TRAFFIC SAFETY COMMISSION
MEETING AGENDA

MEMORANDUM

Re: Traffic Safety Commission Meeting on September 4, 2025

2. PC25-07 – Station 85-Hundred (8500-8550 Lehigh Avenue)

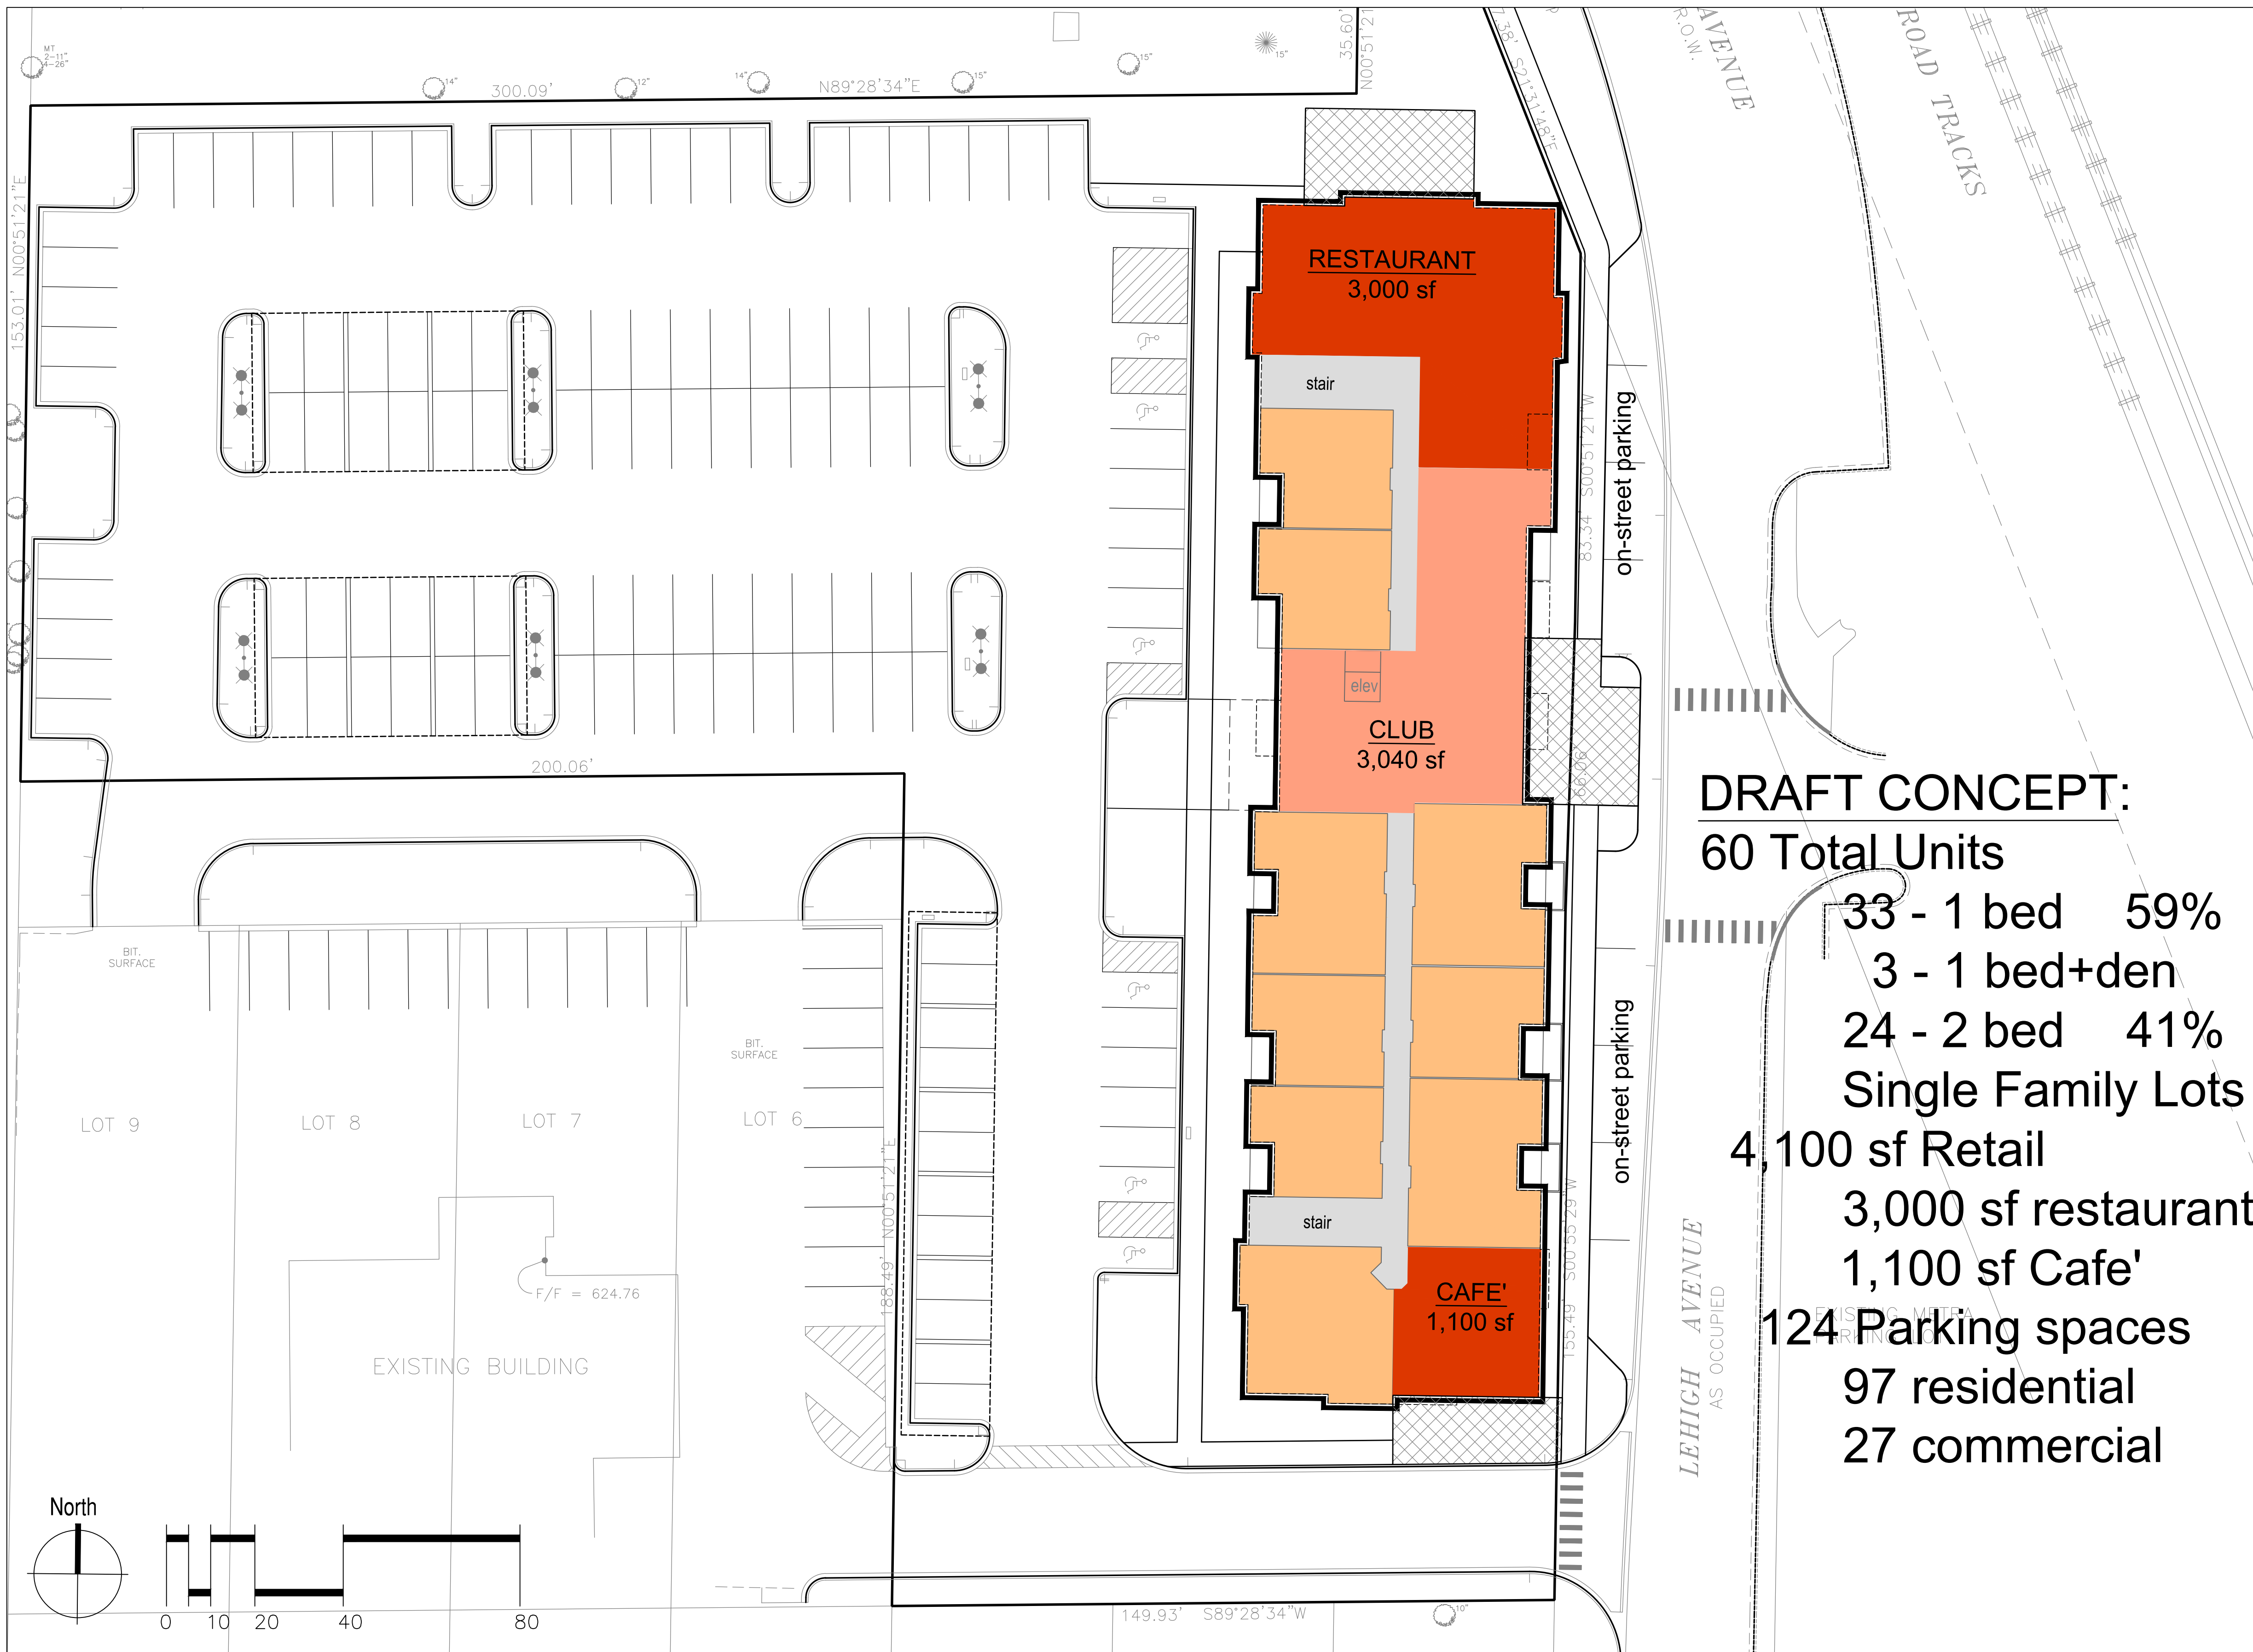
7. **TRAFFIC:** The turning path analysis exhibit for fire apparatus should have used the longest vehicle for the analysis. Truck 2 has the longest length and wheel base, but Morton Grove 16 was used with shorter lengths for both of those criteria. It is anticipated the longer vehicle would be able to circulate, but it is possible the parking bank may need to be shortened by one parking space (potential loss of 4 parking spaces).

10. **SITE PLAN:** The turning path analysis exhibits show the circulation of a single unit garbage truck and fire truck. However, a multi-unit vehicle should be analyzed to evaluate a delivery truck's ability to circulate through the parking lot. The special use permit should include conditions to mitigate the impact of a delivery vehicle that exceeds the length of the loading berths. Measurable parameters such as location on the site, time of day for deliveries, and duration of loading could be considered to reduce the impact to an acceptable level to all users. Additionally, moving trucks can be expected for the residential buildings and this impact should be understood and controlled. Lehigh Avenue will need to be prohibited from any and all delivery activity. It should also be shown how an emergency vehicle could enter the site from the north fire lane when the largest design vehicle expected is parked in the loading area.
